DEVELOPMENT REVIEW COMMITTEE (DRC) COMMENT REPORT

**Project Name: LIPAO FLA 2 LLC / 1416 NE 4th Avenue
Commercial Building**

Case Number: R16009

**Request: Site Plan Level II Review: 1080sf Commercial
Building within 100 feet of Residential Property**

4 NORTH ELEVATION
A-200 1/4" = 1'-0"

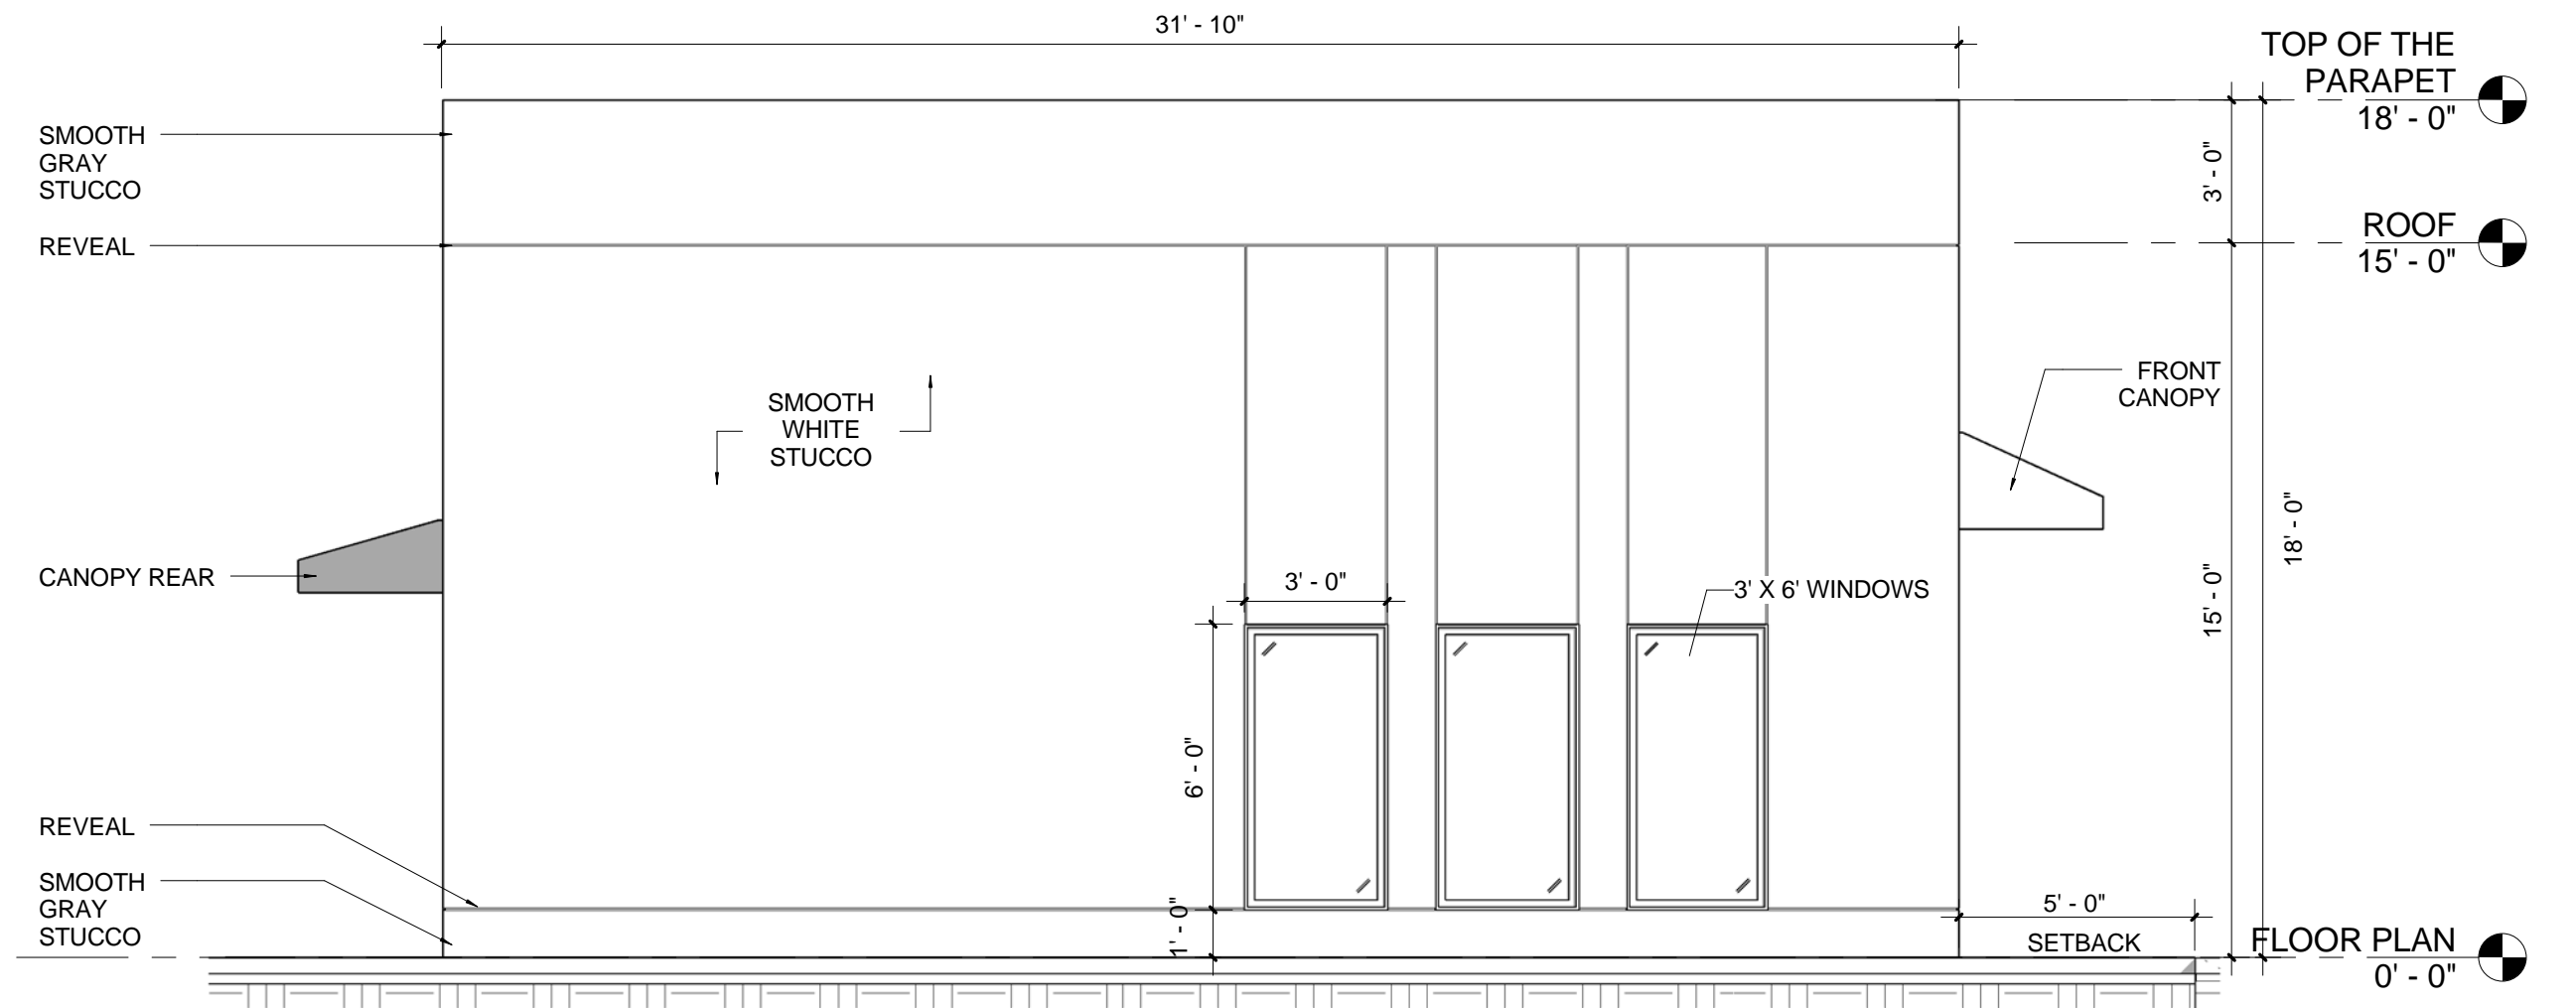
9. Sheet A-200: Show and label Right-of-Way boundary as appropriate on building Elevation drawings, to convey that the proposed front building canopy along N.E. 4th Avenue doesn't encroach into the Right-of-Way.
